LAND USE APPLICATION SUMMARY

Property Location: 2640-50 Hennepin Avenue S
Project Name: Walgreen's
Prepared By: Kimberly Holien, Senior Planner, (612) 673-2402
Applicant: SOMSAP, LLC
Project Contact: Marcie Weslock, Elan Design Lab
Request: To construct a 16,317 square foot retail building with a drive through.
Required Applications:

Site Plan Review	For the construction of a 16,317 square foot retail building with a drive through
Minor Subdivision	To adjust the common lot line between two parcels

1 SITE PLAN
1" = 20'

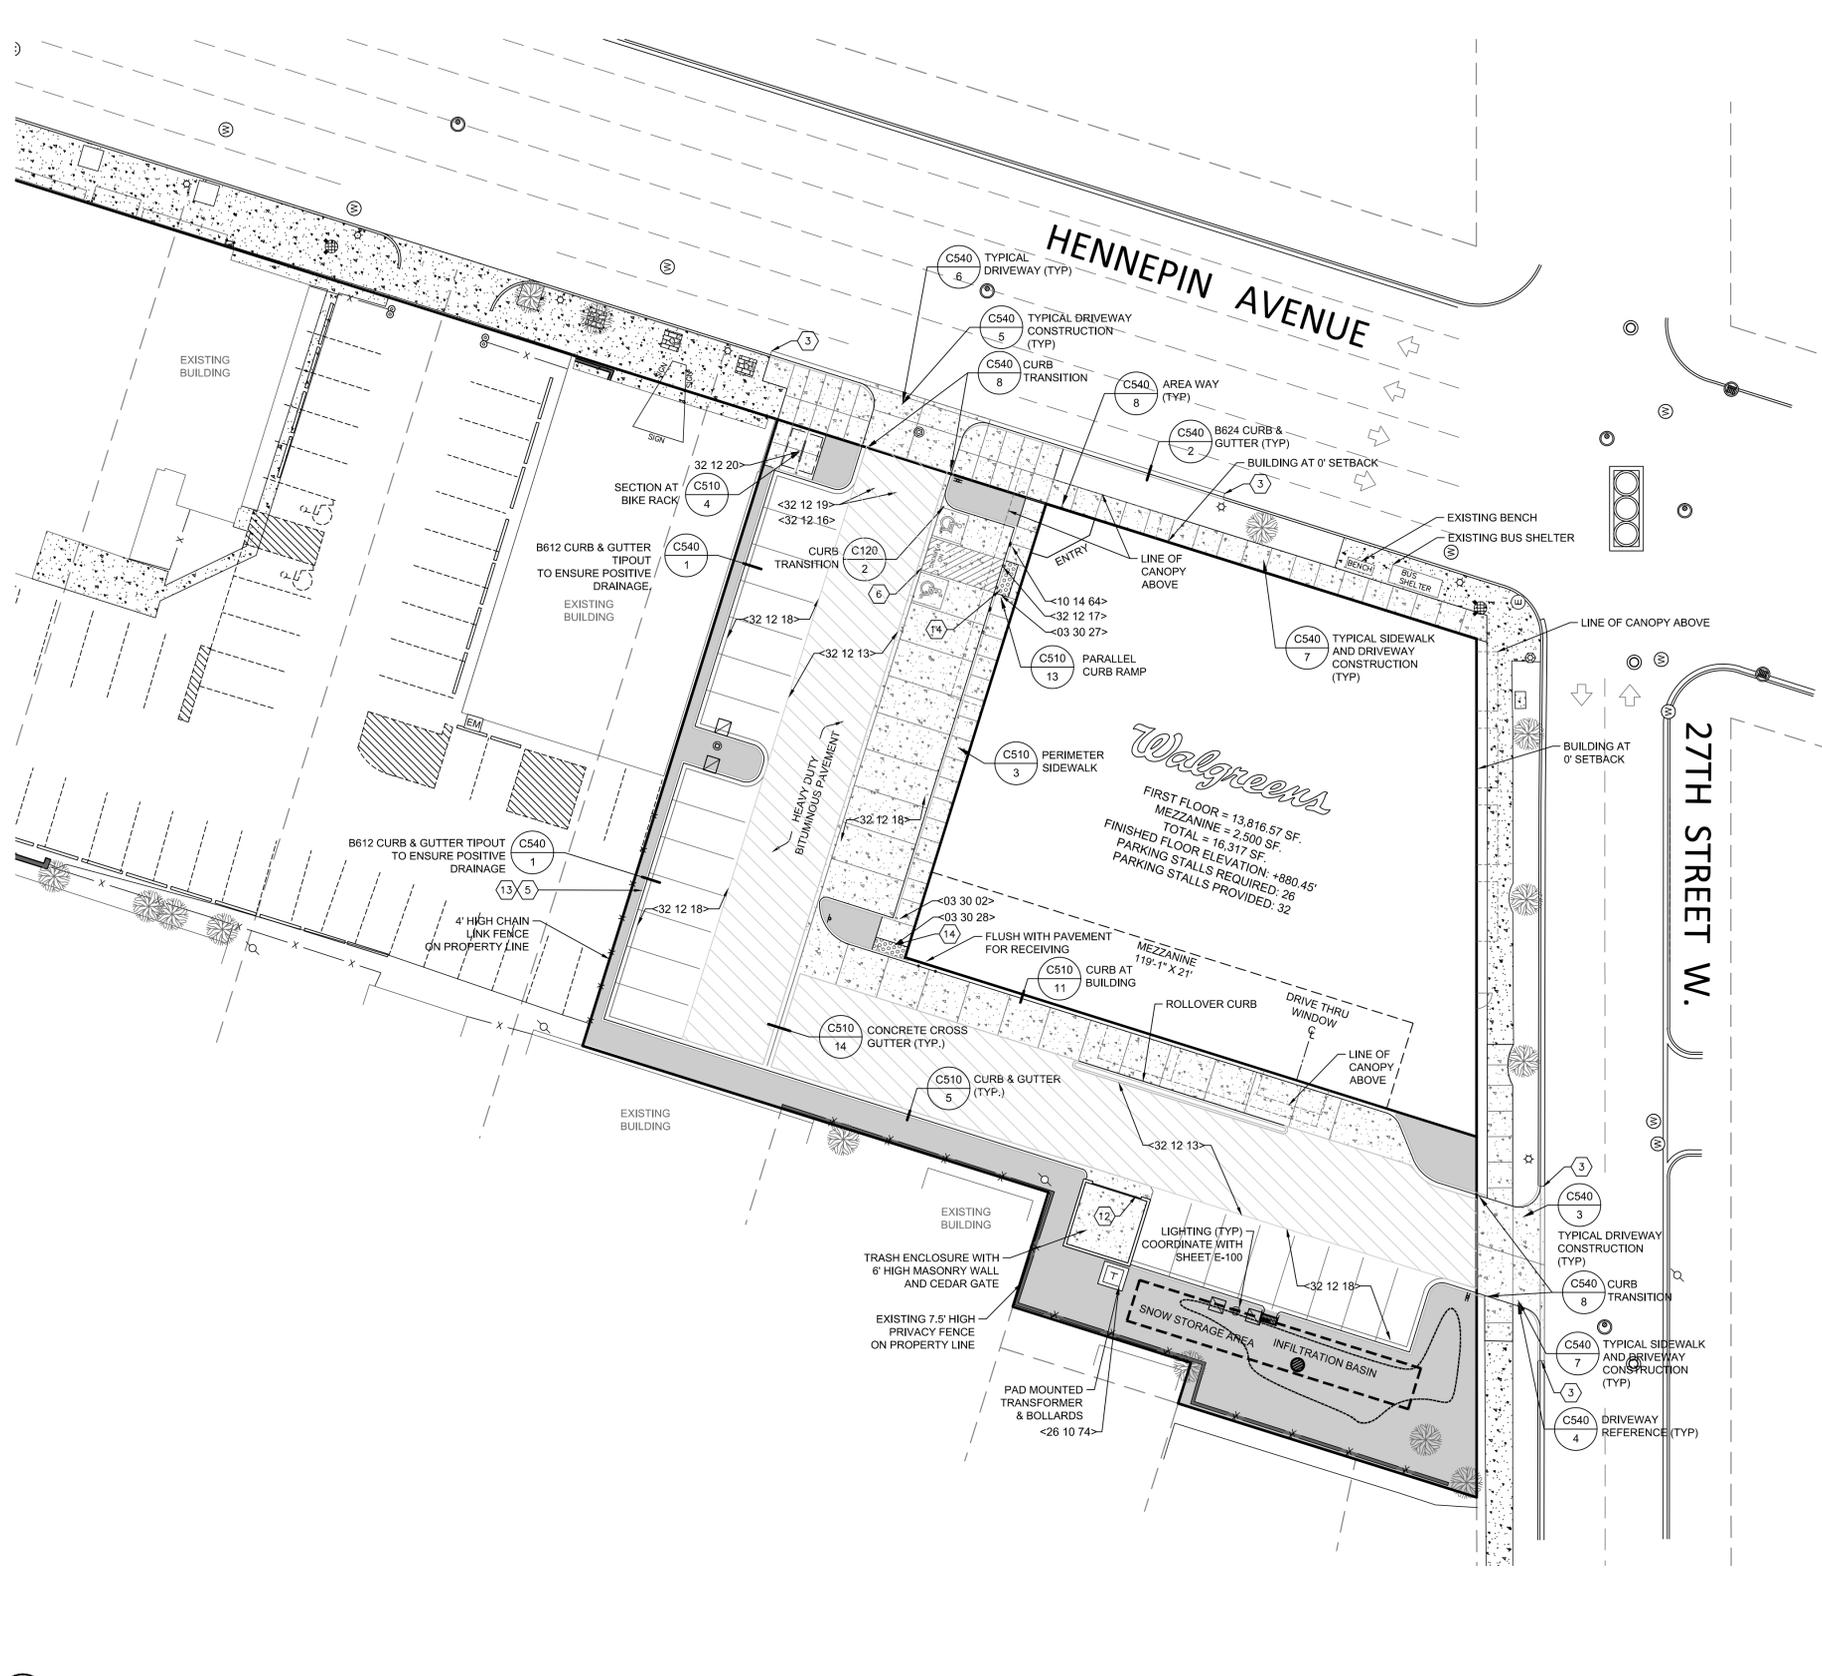
- The applicant is proposing screening that is a minimum of three feet in height and 60 percent opaque in both locations. The screening is comprised of densely planted shrubs. The applicant is proposing to locate the bike parking in the landscaped yard on the north side of the Hennepin Avenue curb cut. As a condition of approval, staff is recommending that the bike parking be relocated and replaced with landscaping in this location.

- The applicant submitted a photometric plan that shows maximum readings of 1.2 footcandles along the west property line (adjacent to residential) and a maximum of 2.3 footcandles on the south property line. As a condition of approval, the lighting will need to be rearranged so as not to

- The parking lot exit on to Hennepin Ave shall be signed as right turn only.
- The Applicant shall note the location of any existing Metro Transit "bus stops" on the site plan.

- Per City Ordinance the Applicant shall provide for (and identify) a solid waste collection point (SWCP) on the site plans. The location of the SWCP is subject to the review and approval of the Public Works Department.

3 WEST ELEVATION
1/8" = 1'-0"

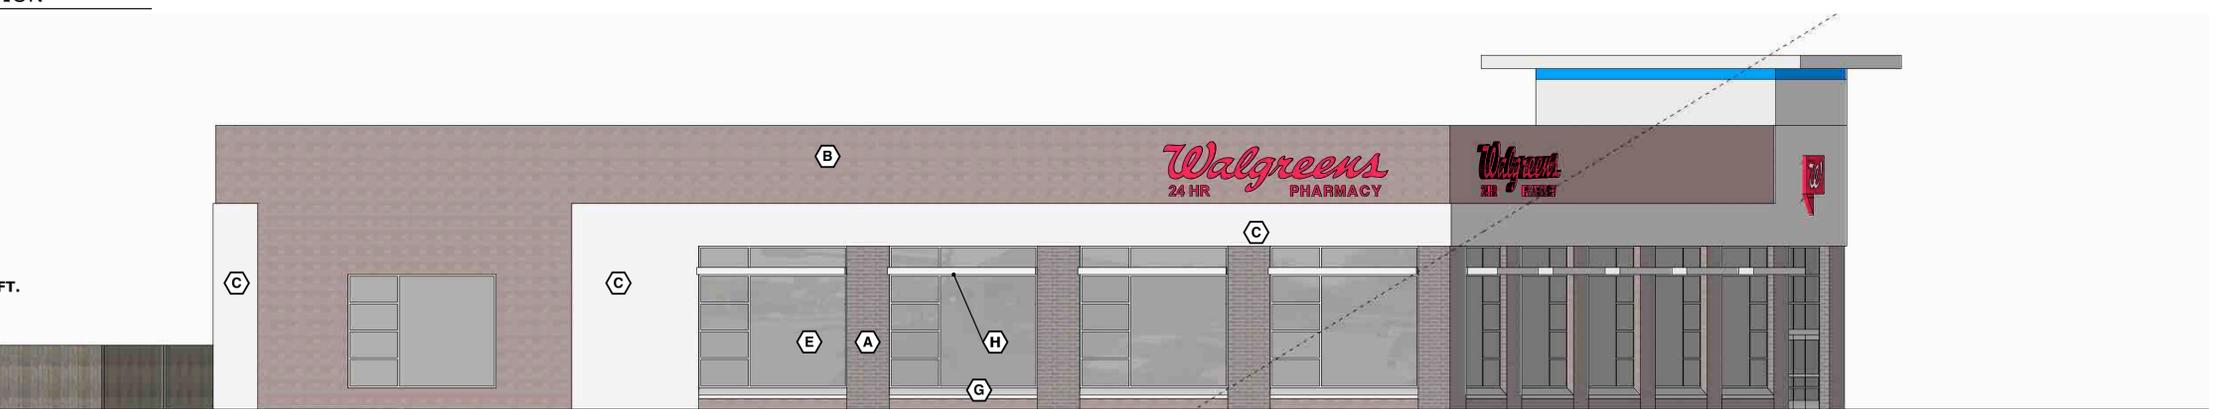
- For nonresidential uses, the zoning code requires that no less than 30 percent of the walls on the first floor are windows with clear or lightly tinted glass with a visible light transmittance ratio of six-tenths (0.6) or higher. No less than ten percent of the walls on each floor above the first that face a public street, public sidewalk, public pathway, or on-site parking lot, shall be windows. Based on the floor plans, all proposed shelving, mechanical equipment, and other similar fixtures allow views into and out of the building between four and seven feet above the adjacent grade. The project is in compliance with the minimum window requirement (see Table 3) on the first floor of the north, east, and south elevations. Alternative compliance is requested for the window requirement on the west elevation. The overall height of the building is 30.3 feet in the northeast corner and 26.6 feet for the rest of the building. The zoning code allows the first story of a building to be a maximum of 20 feet in height. Per this definition, the remaining height of the building is considered a second story and therefore has a window requirement. No windows are proposed in this location. Alternative compliance is requested.

6. Clerestory windows shall be provided on the west elevation, opposite the receiving area, to reduce the length of the blank walls in compliance with Section 530.120 of the zoning code and provide an alternative to the minimum window requirements

5. Windows on the west elevation and in the southwest corner. It has been requested that windows be added along the west elevation in addition to those proposed in the employee break room area. Windows are also requested on the south side of the building in the employee break room.

- a. The floor plan along the west wall largely includes storage and pharmacy uses, which cannot have vision glass for security and privacy reasons. We can and will add glass to the south elevation at the break room and the office.
